Errata

SLG46517

CE-GP-001

This document contains the known errata for SLG46517 and the recommended workarounds.

Figure 1

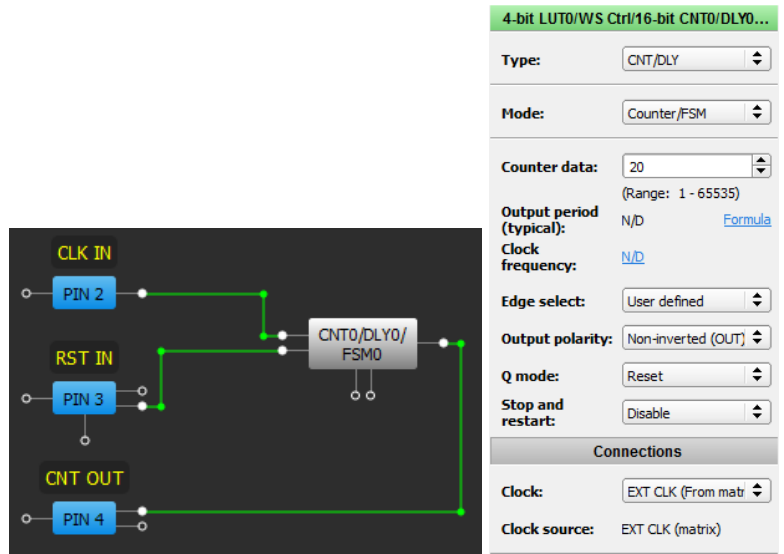
If the Counter Reset is asserted at the same time as a rising clock edge, it is possible that the Counter Data will be reset incorrectly and the counter output may appear faster than expected. This phenomenon appears more often as the clock frequency increases.

Synchronize RESET input of the Counter with its CLK using 2 DFF cells as shown on Figure 3.

Figure 4

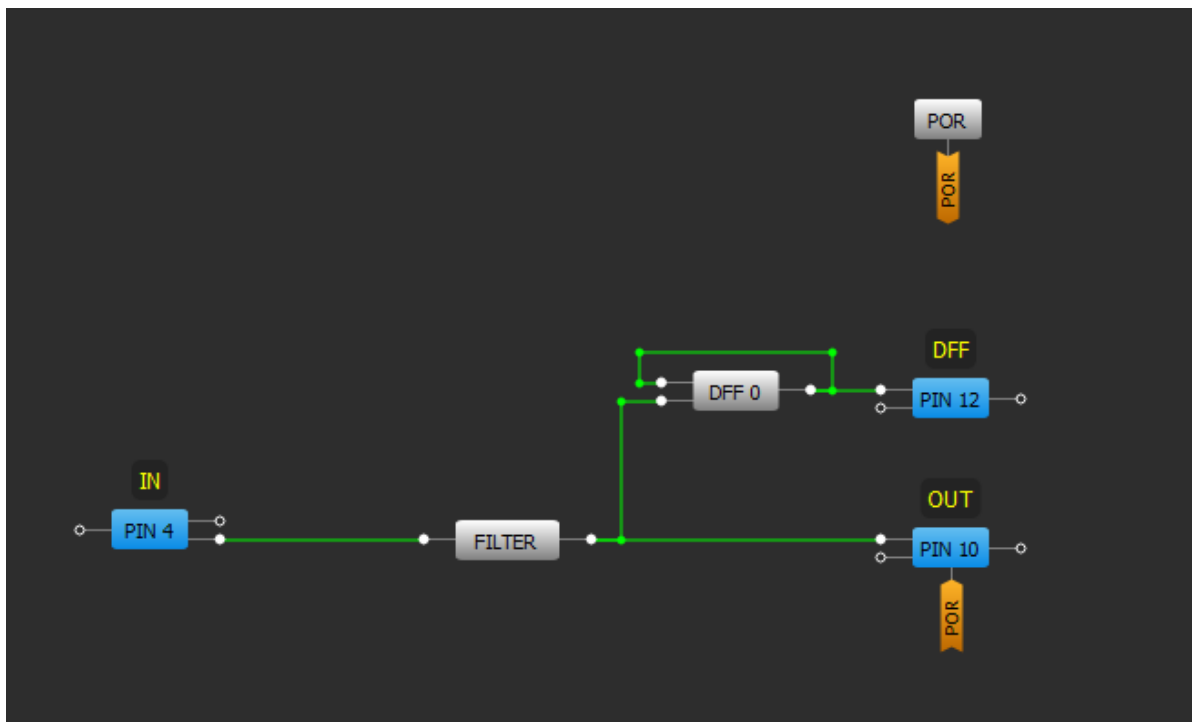
If clock type high frequency input comes in, the FILTER cell may not filter out it. There are several factors like input frequency, duty cycle and LOW duration in such signal that may lead to its passing through FILTER block.

1. Period is 60ns. Pulse width is 10ns DC=16.7% (Correct functionality)

Currently there is no workaround for this issue. Filter block is good at filtering short spontaneous glitches. It is intended to be used in series connection before the delay cell to avoid its latching.

Figure 5

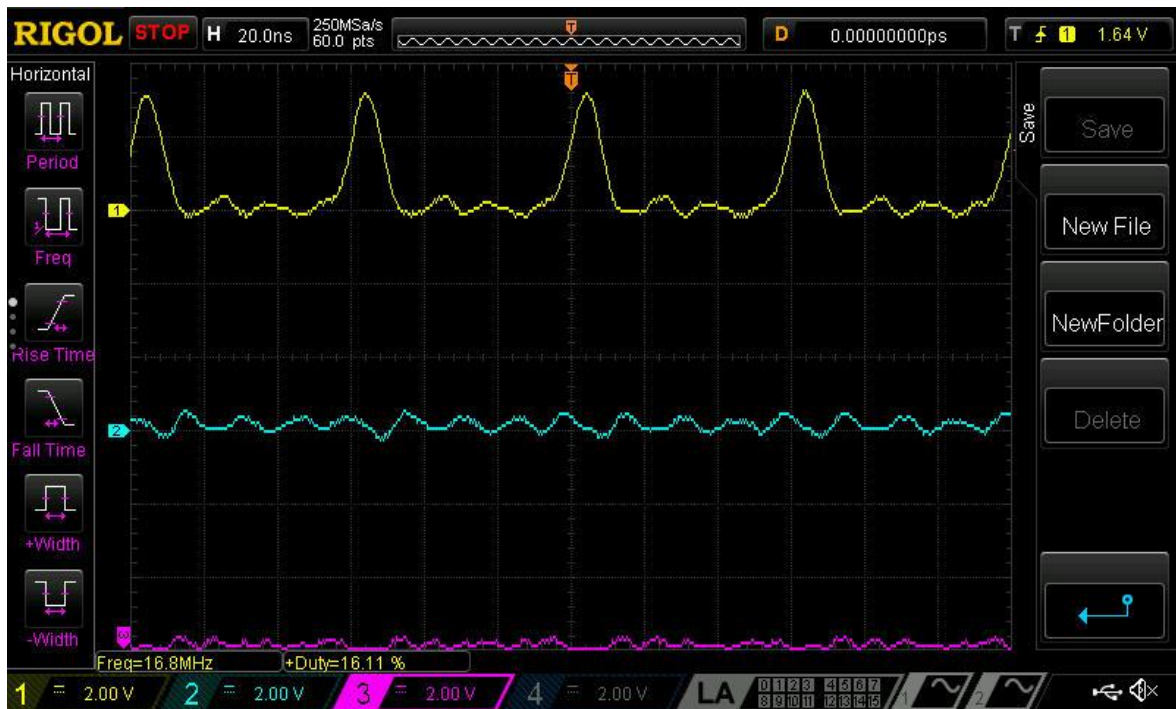
2. Period is 60ns. Pulse width is 20ns DC = 33.3% (Incorrect functionality)

Figure 9

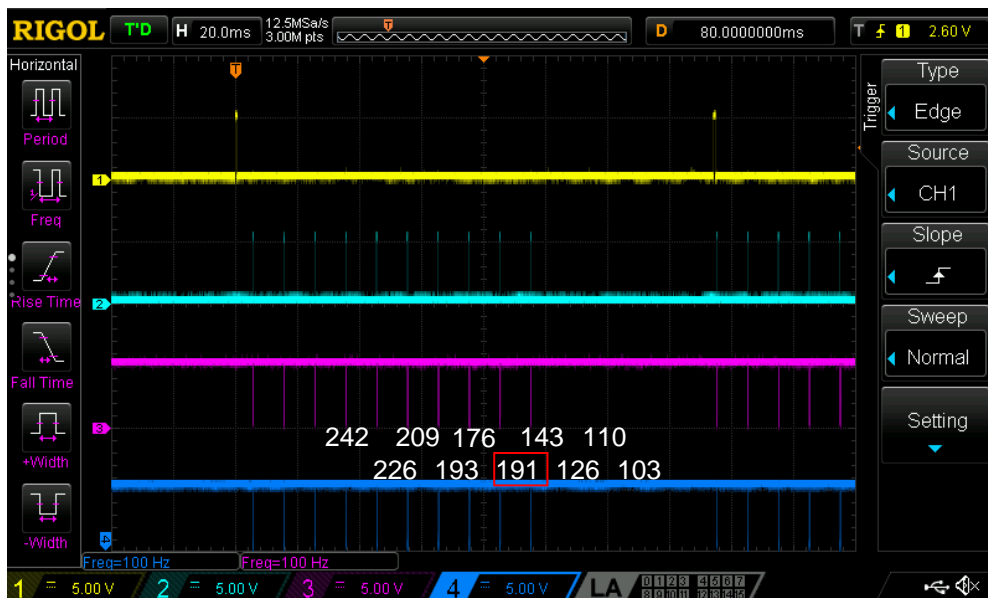
Asynchronous interaction between the CNT/DLY clock input and the I2C latch signal (generated by an I2C read command of the CNT/DLY block's count value) can result in an incorrect I2C data read. The CNT/DLY block will count accurately, but the count value transferred into the block's I2C read register might be loaded incompletely if the I2C latch signal and the clock input occur at about the same time.

The example data capture below shows ten periodic I2C reads of CNT2/DLY2 configured to count down at about 16 clocks per read. The sixth read sample erroneously shows a value greater than that of the fifth. The seventh sample reads as if the previous I2C error never occurred - the difference from the fifth sample (176) to the seventh (143) is 33 clocks or 16 clocks + 17 clocks as expected.

If the possibility of incorrect I2C data reads can't be accommodated for by external software checks, one can guarantee proper operation by stopping the CNT/DLY block's clock during I2C reads

through one of the following methods: by disabling the oscillator block, by reconfiguring the CNT/DLY block's clock source, or by gating an external clock using a LUT (Look-up Table) in the signal matrix. After disabling the CNT/DLY block's clock, the count registers can be read without error. Please note that this workaround will add the I2C read and processing time to the counter's overall clock period.

Figure 10: I2C Write of 16-Bit Counter Data Example

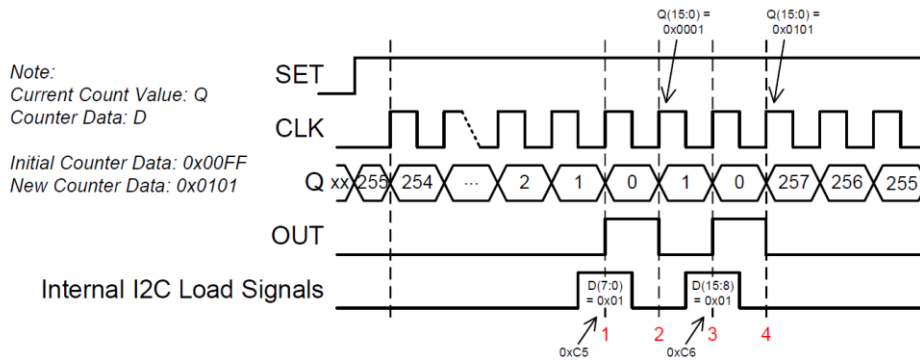
The timing diagram in [Figure 10](#) sets up a case where an improper output will be seen on the counter. In this example, the initial Counter Data value (D) is set up as 0x00FF. As you can see, the

Current Count Value (Q) decrements from 255 down to 0 with rising edges on CLK. At time “1” denoted by a red number 1, an I2C command (not shown) has just been sent to the GreenPAK device to reconfigure the Counter Data value to 0x0101.

As previously mentioned, the 16-bit value is loaded from the I2C buffers to the Counter Data registers in 8-bit chunks. Right at time “1”, the LSB byte (0x01) is loaded into the Counter Data registers. This makes the Counter Data value temporarily equal to 0x0001. At time “2” between the internal I2C load signals, the counter receives a rising edge on its clock input. This causes the Current Count Value to underflow and to be loaded with the Counter Data value which is 0x0001. At time “3”, the MSB byte (0x01) is loaded into the Counter Data registers setting the Counter Data value to 0x0101. At time “4”, the Current Count Value underflows again and is set to the Counter Data value of 0x0101.

won't be gated internally which avoids the loss of count values during Tstop. In order to guarantee the current count value after an I2C write to the Counter Data registers, the clock should be manually stopped for the I2C write or a SET/RESET command should be generated after the I2C write. (Case 1)

I2C Write of Counter Data: Accommodate for the double pulse described in Case 1.

Figure 11: 16-Bit I2C Counter Block Diagram

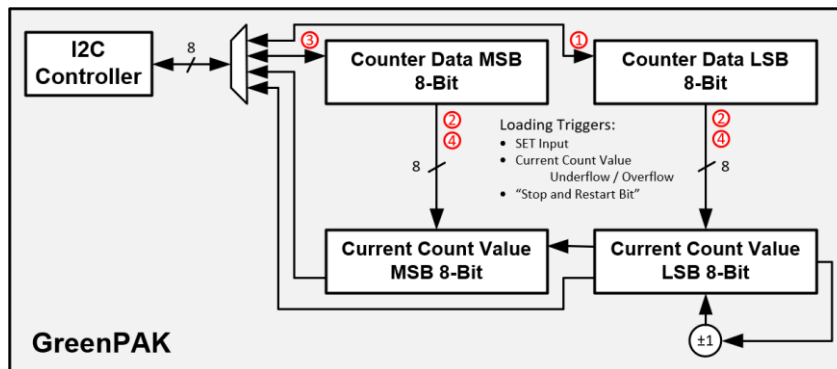
This behavior results in two output pulses on OUT when only one pulse is expected. Observing this behavior depends upon the asynchronous timing between the counter’s clock and the I2C write command to the Counter Data registers. For some applications, the extra pulse on OUT can be ignored and the counter will self-correct after underflowing, overflowing, or being SET/RESET through the GreenPAK connection matrix.

Figure 12: Counter Behavior

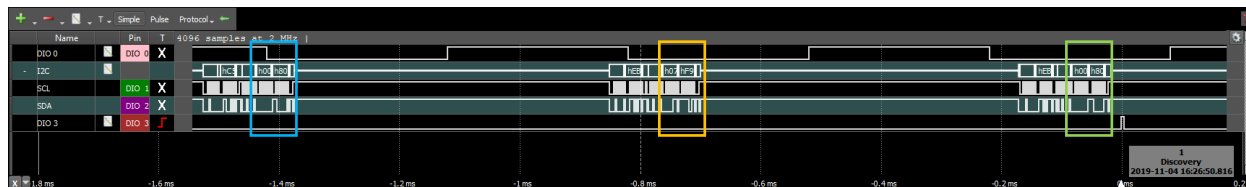
For the following condition, the Counter Data register contents are unexpectedly loaded into the counter’s DFF chain. This behavior occurs when there is a falling edge on the counter block’s clock input during the data return portion of an I2C read of the Counter Data registers. Figure 10 shows this falling edge boxed in light blue followed by two I2C reads of the Current Count Value registers.

As you can see by the MCU data log below, the Current Count Value gradually increases from 0xF904 to 0xF907 but is unexpectedly reset to 0x8000. Please note that the colored HEX values in the MCU Log correspond to the boxed I2C read commands shown in the waveform above. As previously described, this reset occurs because there is a falling edge on the counter’s clock input while the GreenPAK device is responding to an I2C read request to 0xC5 and 0xC6. (Note that 0xC5/0xC6 are the Counter Data registers and 0xEB/0xEC are the Current Count Value registers for CNT0.)

The reason that the counter isn’t set to 0x8000 on the I2C read immediately following the Counter Data query is because the counter requires two rising edges on its clock input to load the data from the Counter Data registers into the DFF chain. Note that all rising edges during T_{stop} will be gated internally by the “Stop and Restart” feature.

For systems that require I2C write access to the Counter Data registers while the counter is clocking, enable the "Stop and Restart Bit." (Case 2)

I2C Read of Counter Data: Avoid reading Counter Data via I2C while the counter is being clocked.

Within the MCU, we recommend saving the Counter Data register configuration as a software variable so that the Counter Data register doesn't need to be read during counter operation.

Figure 11

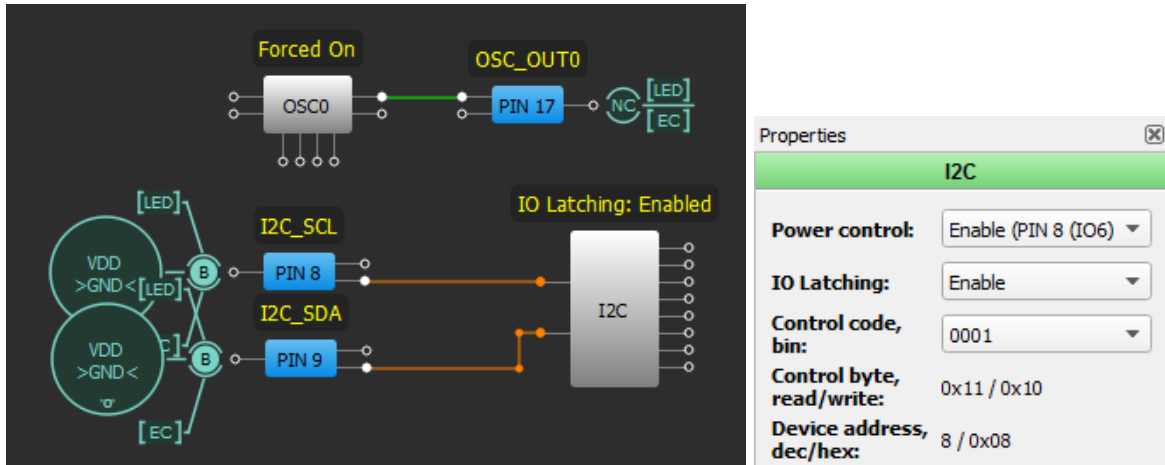
The GreenPAK device does not check for a matching I2C Slave address condition before triggering 'IO Latching'. A Start bit on the I2C bus will trigger IO Latching. A Start bit is when I2C_SDA goes low first followed by I2C_SCL going low after.

In the example below, we will be monitoring the OSC output, which is measured by a scope on Channel 3 via PIN17 ("OSC_OUT0"). The I2C bus will be forced low to create a START bit.

Disable IO Latching in programmed OTP. This register is I2C-write locked during normal operation and therefore should be disabled in configuration file.
Do not share I2C bus with other devices and make sure the I2C bus is not powered down while the GreenPAK is still powered through VDD.

If the above cannot be satisfied, then consider using the SLG4658x devices, where this errata has been fixed.

Figure 12

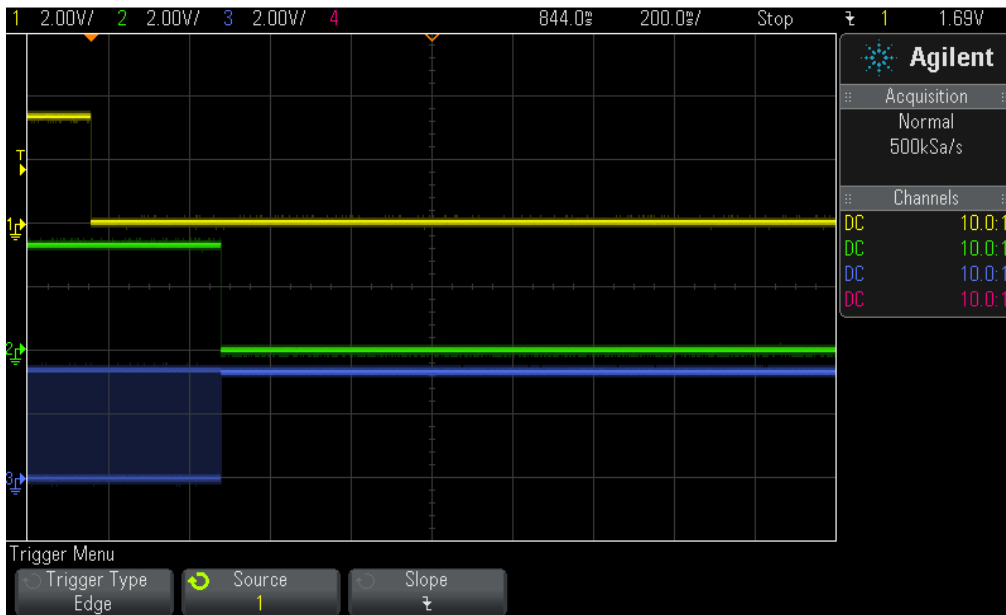
By toggling I2C_SDA low and then I2C_SCL low, the GreenPAK registers this as a start bit and latches all General Purpose Outputs such as PIN#17(“OSC_OUT0”). In the Figure 12, notice that PIN#17 (OSC_OUT0) stops toggling.
